Technical Service Bulletin: tsb100290

New Front Engine Support Bushing

This Technical Service Bulletin is to inform the field of a product change for QSK45, QSK60 single stage and QSK60 two stage, front engine support bushing.

Figure 1

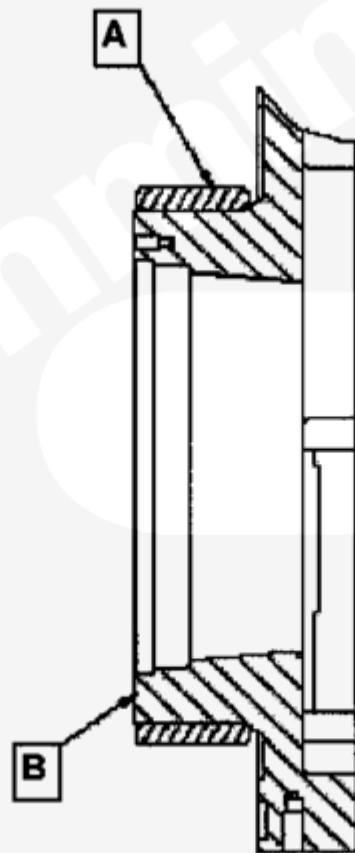
The purpose of this change was to eliminate possible interference issues with the front cover radius when the bushing was installed.

- New Part Number: 4101322
- Old Part Number: 4065741

Due to this change the installation tolerances have also changed when installing the bushing to the front cover.

Press the bushing (item A, Figure 1) until it is flush to 1.0 mm [0.040 in] MAX the surface (B, Figure 1).
